AGENDA
Planning & Zoning Commission
Tuesday, March 2, 2021
6:00 PM

STAFF REPORT AND CERTIFICATE OF RECOMMENDATION

PROJECT: Powell Park Annexation

TO: Planning & Zoning Commission

Figure 3 Proposed Swap Parcels

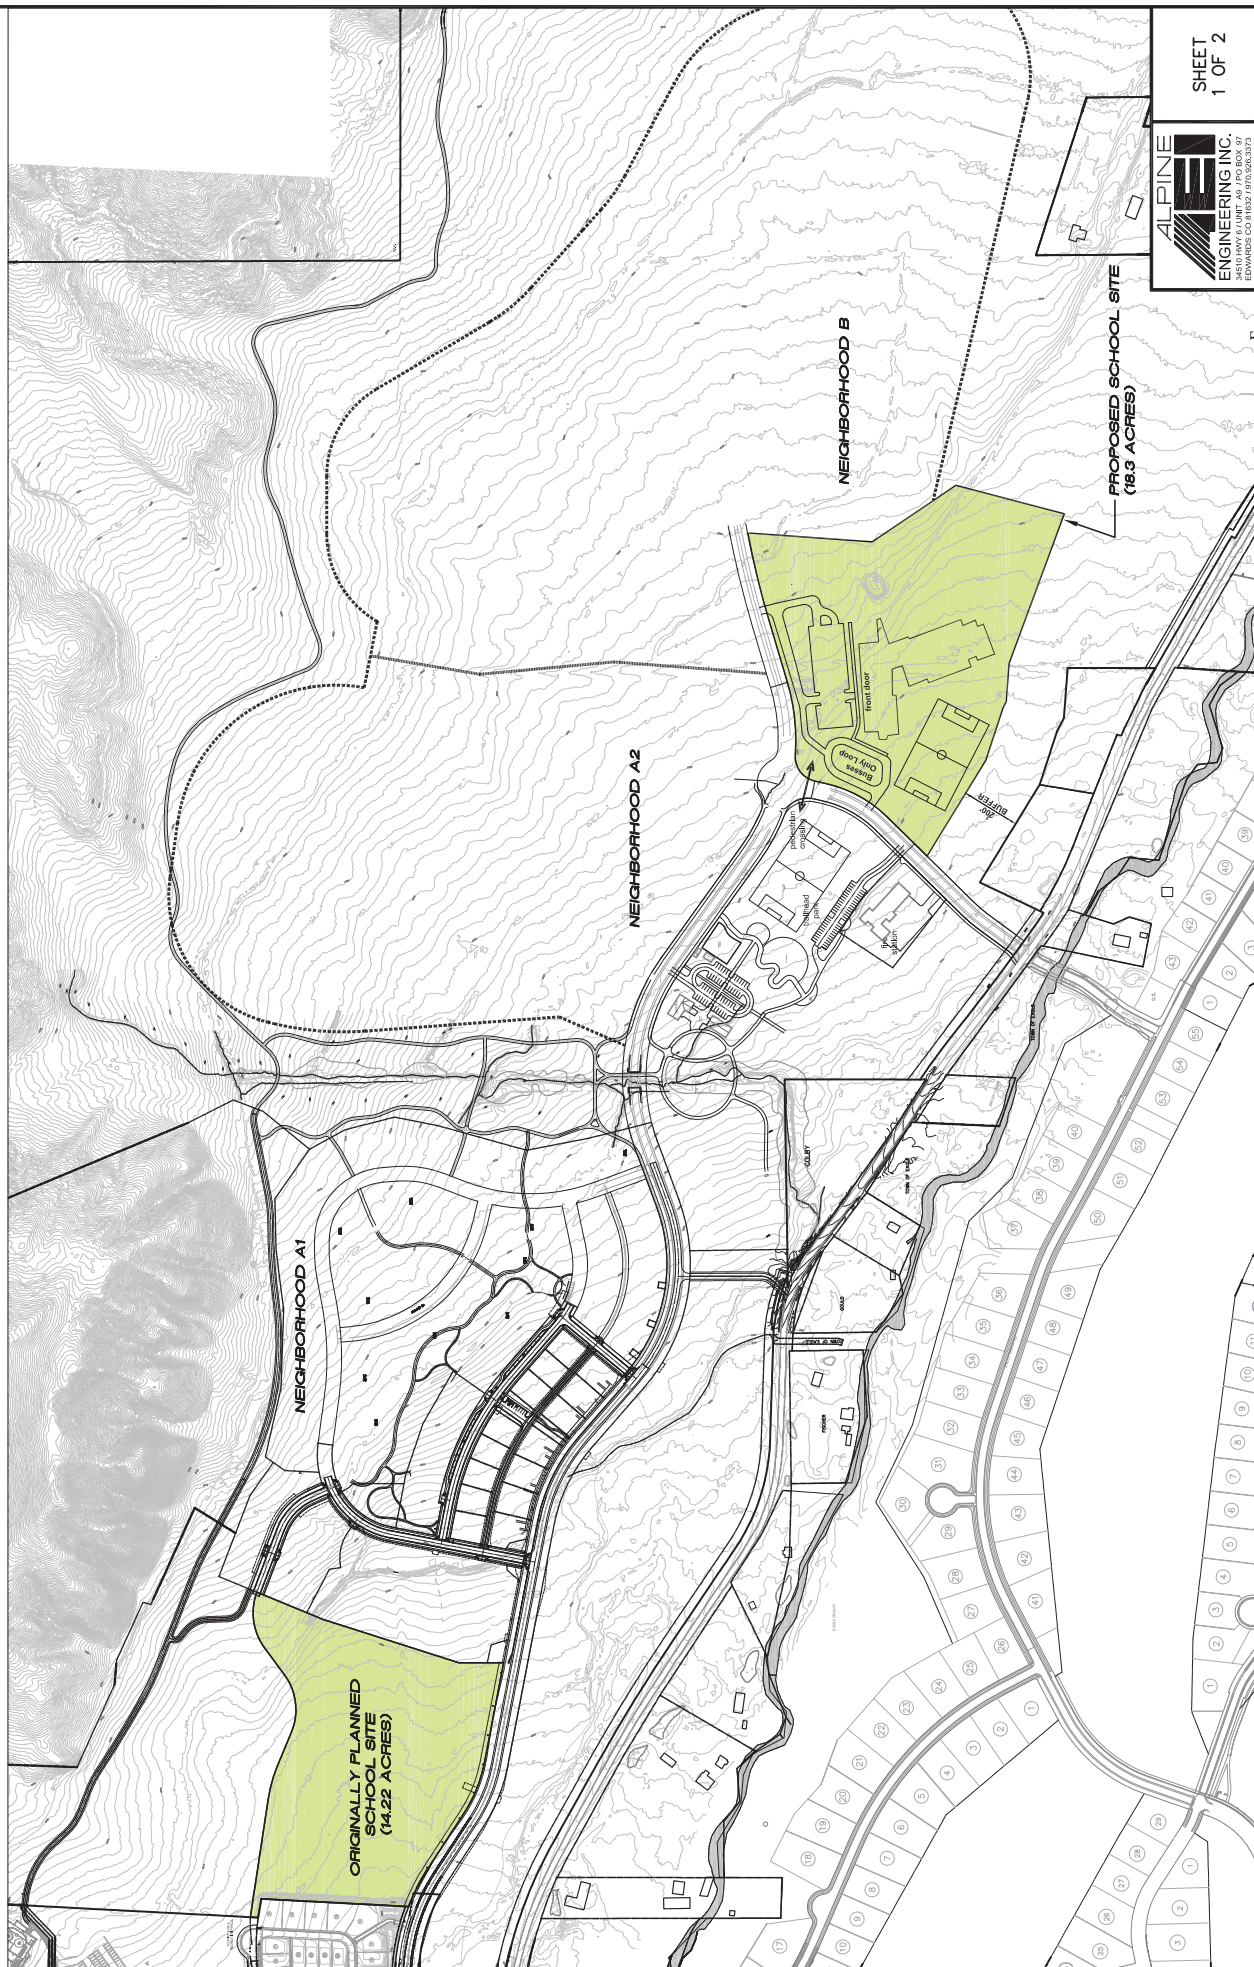
Staff Comment – School Swap: The school swap request is partially consistent with the clustering of housing towards more developed areas of land encouraged by the 2010 Eagle Area Community Plan (EACP), except that clustering is primarily encouraged in and around established commercial centers. The initial plan distributed multi-family housing throughout the PUD and into Neighborhoods A1, A2, B, and C. The amendment allows for housing stock to be built and enter the market sooner in the project phasing, but restricts all multi-family housing to only Neighborhoods A1 and A2, with the expansion of A1 by 14.2 acres.

Staff Comment – School Swap: The school swap request does not affect the approved open space plan for the development. Should this request be approved, the applicant has agreed to create a landscape buffer to provide a visual boundary and a “landscaped open space” area resulting in 2.6 acres between the Soleil Development and multi-family housing. This portion of open space would not be part of the open space plan but would be part of the landscape portion of the Design Guidelines. Staff believes that the proposed amendment does not contain an open space plan that differs substantially in quantity or quality from that originally approved.

Figure 6 Conceptual Cabin Site Plan

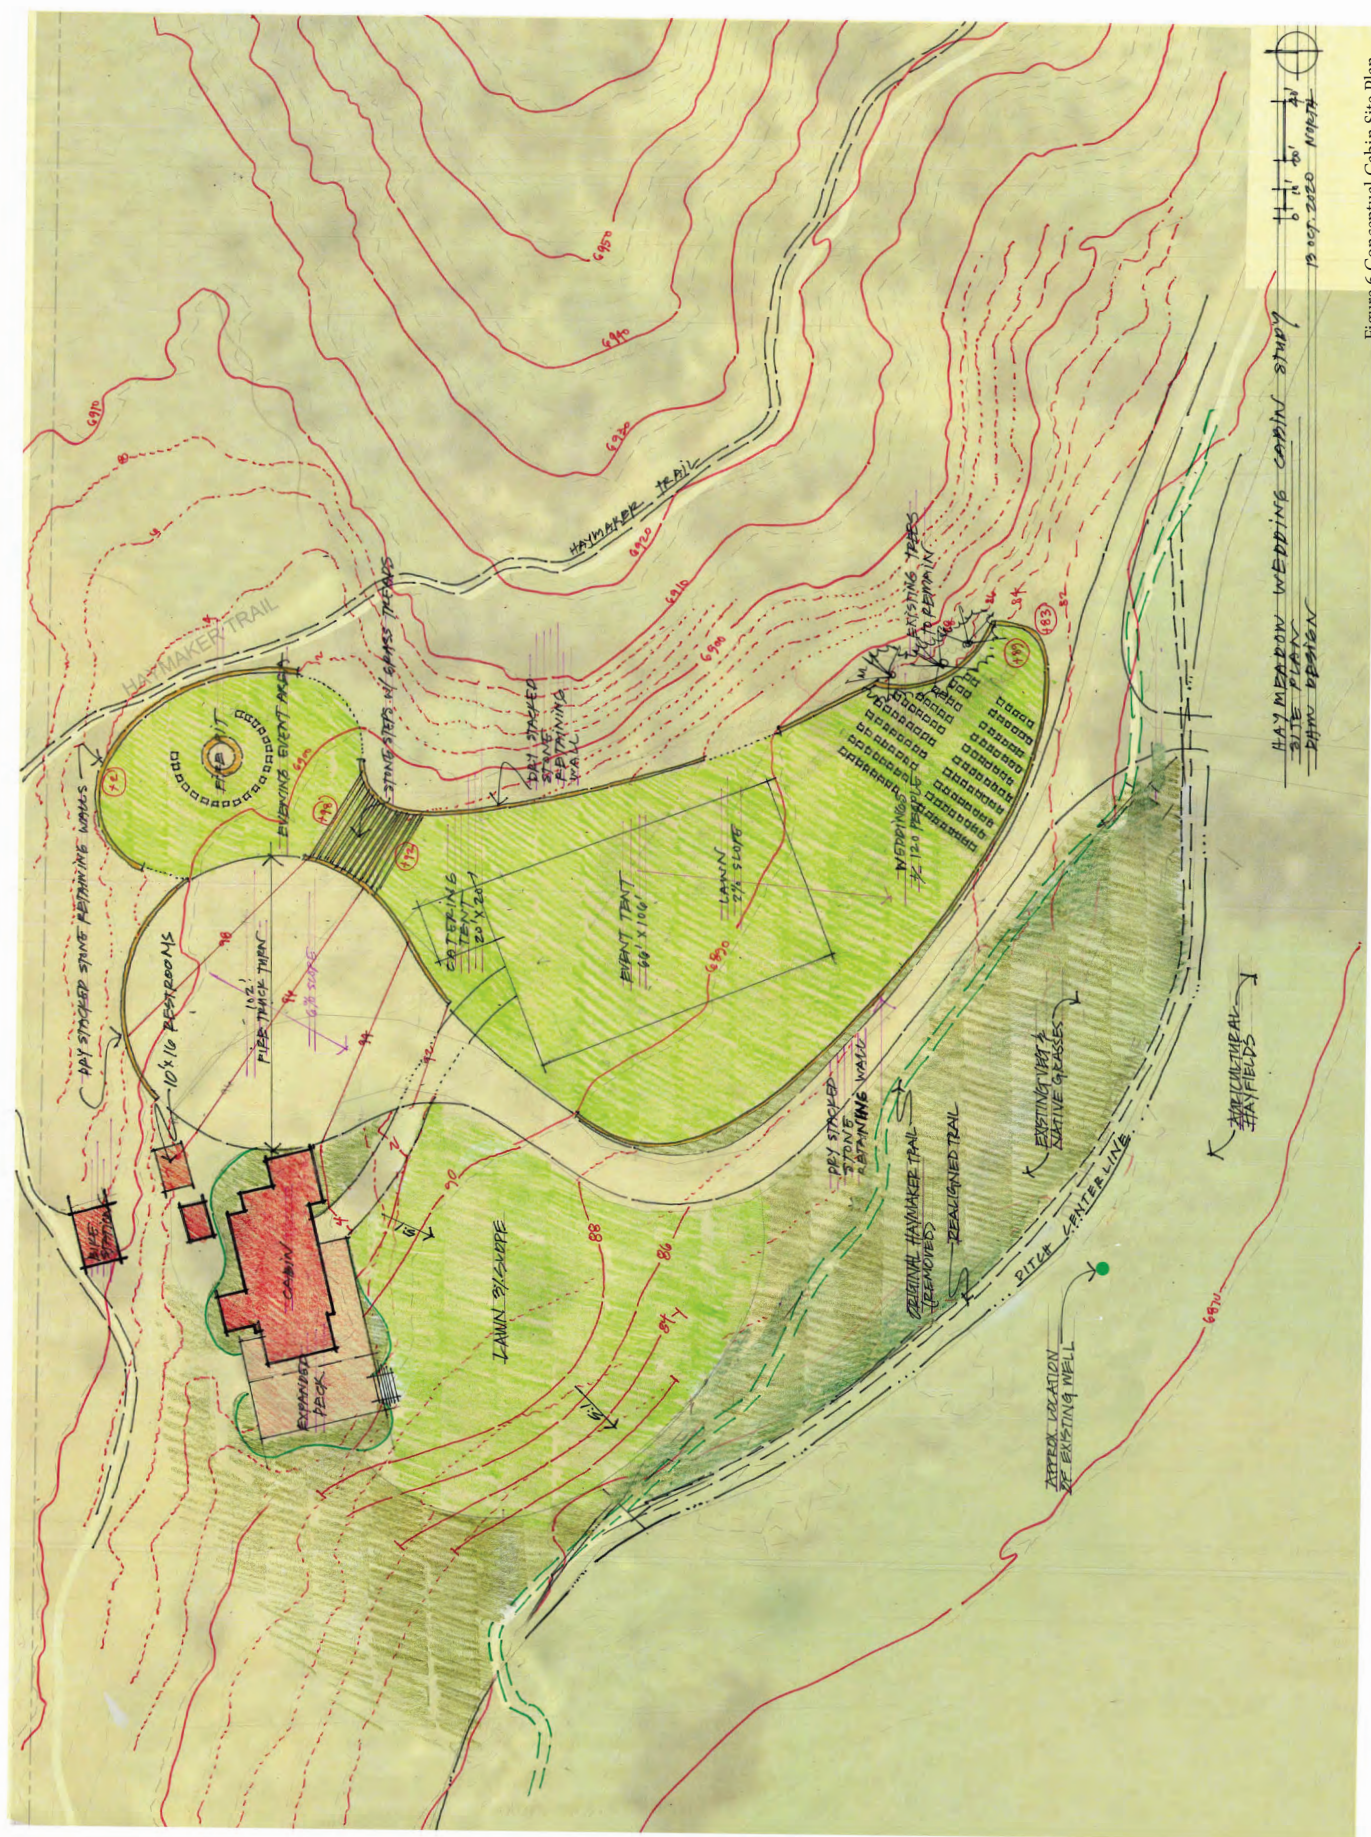
Staff Comment – Cabin: An existing dirt road currently leads to the cabin, situated just east of Neighborhood D. On the site plan, the road is shown only as existing but not to remain. When Neighborhood D is platted, the applicant and the development team will need to show how access will be maintained, but as the Neighborhood is not yet platted, staff does not have concerns about the cabin as it relates to coordination with the overall street and utility plans.
